Access Compliance Report

Public Rights-of-Way

Intersection ID: 43145	Main Street: E_INDEPENDENCE_BV	Cross Street: E_INDEPENDENCE/BRIAR_CREEK_RA	Location: SW
ADA ID: 43257D2F18FE	Ramp Type: Perp	Initial Pass/Fail: Fail	Overall Compliance: No
Severity Score: 33.75			
Codes/Mitigation Info/Possible Solution		Field Measurements/Component Compliance

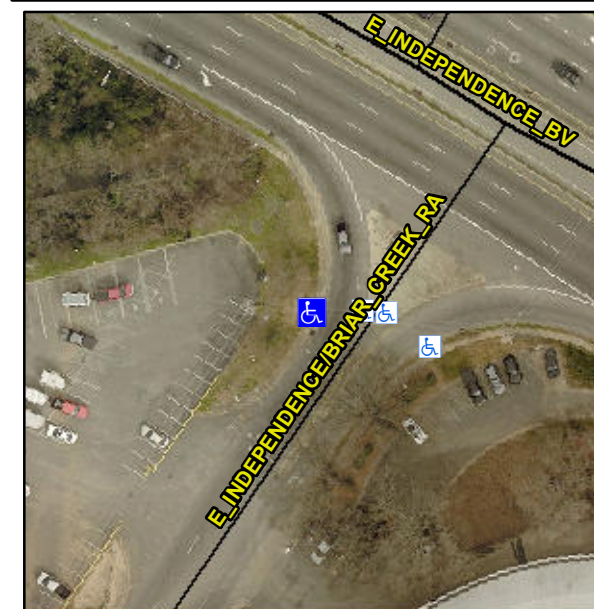
Not Found, R304.5.1, R304.2.2

Compliance	Description	Data	Compliance	Description	Data
N/A	Ramp Length (in)	49.0	No	Ramp Slope (%)	12.3
No	Ramp Width (in)	36.0	Yes	Ramp XSlope (%)	0.0
N/A	Flare Type LT	N/A	N/A	Flare Type RT	N/A
N/A	Flare Slope LT (%)	N/A	N/A	Flare Slope RT (%)	N/A
N/A	Flare Traversable LT?	N/A	N/A	Flare Traversable RT?	N/A
N/A	Landing Length (in)	N/A	N/A	DWS Provided?	N/A
N/A	Landing Width (in)	N/A	N/A	DWS Contrast?	N/A
N/A	Landing Slope (%)	N/A	N/A	DWS Length (in)	N/A
N/A	Landing X Slope (%)	N/A	N/A	DWS Full Width?	N/A
N/A	Landing Curb? (Y/N)	N/A	N/A	DWS Offset (in)	N/A
N/A	Shared Landing?	N/A			
N/A	Gutter Ponding?	N/A	N/A	Gutter Slope (%)	N/A
N/A	Gutter Lip Ht (in)	N/A	N/A	Gutter X Slope (%)	N/A
N/A	Painted X Walk1?	No	N/A	Painted X Walk2?	N/A
	X Walk 1 Direction	To E		X Walk 2 Direction	N/A
N/A	X Walk 1 Width (in)	N/A	N/A	X Walk 2 Width (in)	N/A
	X Walk 1 Slope (%)	3.1		X Walk 2 Slope (%)	N/A
	X Walk 1 X Slope (%)	1.0		X Walk 2 X Slope (%)	N/A

Remove & Replace Entire Ramp.
